## Impact on Scenic and Aesthetic Views Analysis Extended Beyond PSE Study Area

### Abstract

**Figure 1** Number of residents, by blockgroups (represented by shades of blue) according to distance from powerline,<sup>5</sup> whose scenic and aesthetic views would be impacted. (Red dashes on the map represent where powerline crosses public-street ROWs.) Map and data provided by Deron Ferguson

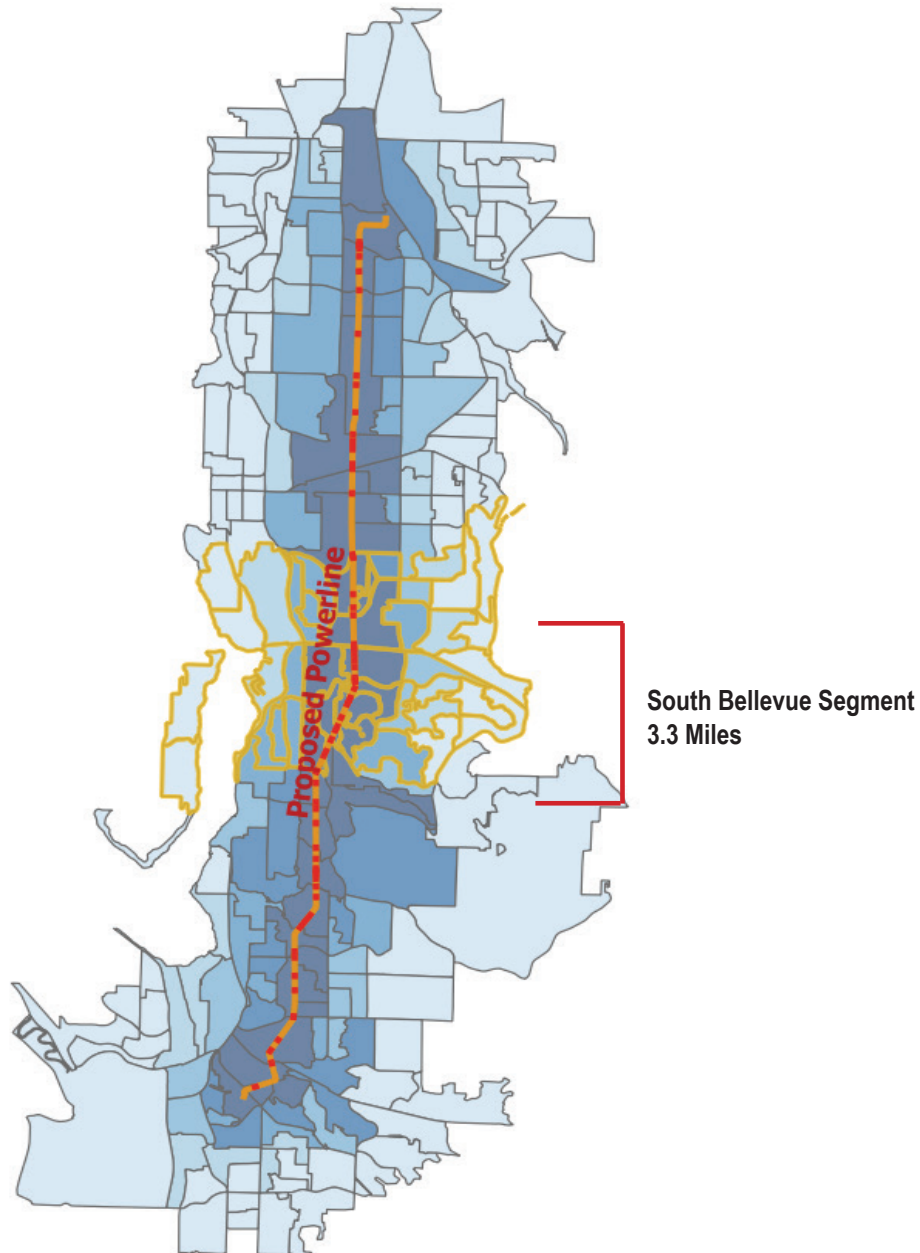
The study area for the visual analysis of the Energize Eastside project was *limited to 0.25 miles* from the edge of the existing transmission corridor. Areas west of I-405 were excluded. The EIS stated: "*while the project would be visible at greater distances, significant visual impacts are not probable given the project's scale relative to its largely mixed urban context.*"<sup>2</sup> This statement does not acknowledge the predominant residential land use in the proposed transmission corridor. Given the numerous locations known for their scenic views on the Eastside, for example the hilly terrain in the Somerset neighborhood, the view from Bellevue City Hall, the park at Lake Boren, or the view from the Woodridge or Enatai neighborhoods looking southeast - the basis of this analysis is shortsighted.

Consider this analysis from the map illustrating the population in *block groups* according to the distance from the transmission corridor.

The number of residents (2010 census) whose scenic or aesthetic views would be impacted along the originally proposed 16 miles of the Energize Eastside Project would be<sup>3</sup>:

- 122,818 residents at *0.5 miles*, and
- 184,434 residents at *1 mile* from the powerline and
- **325,562** residents that are within *2 miles* of the transmission line.

**Figure 1**

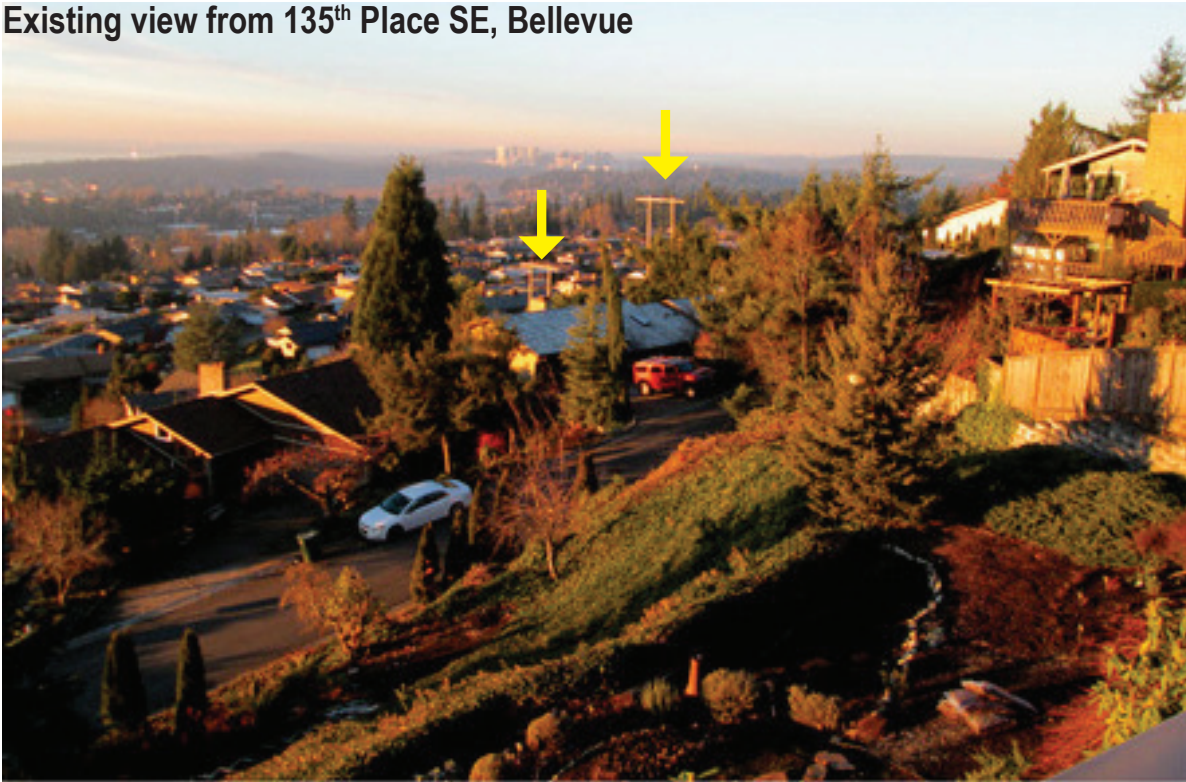
*Top photo of existing 45-foot poles with horizontally-oriented wires that are viewed against land. Bottom photo-simulation of proposed 75-foot poles with vertically-stacked wires viewed against skyline.*

*The 230kV power poles in a residential neighborhood would create significant impact on viewer (resident) sensitivity and dramatic changes to the aesthetic environment. The result would be a severe alteration to the existing character of the neighborhood.*
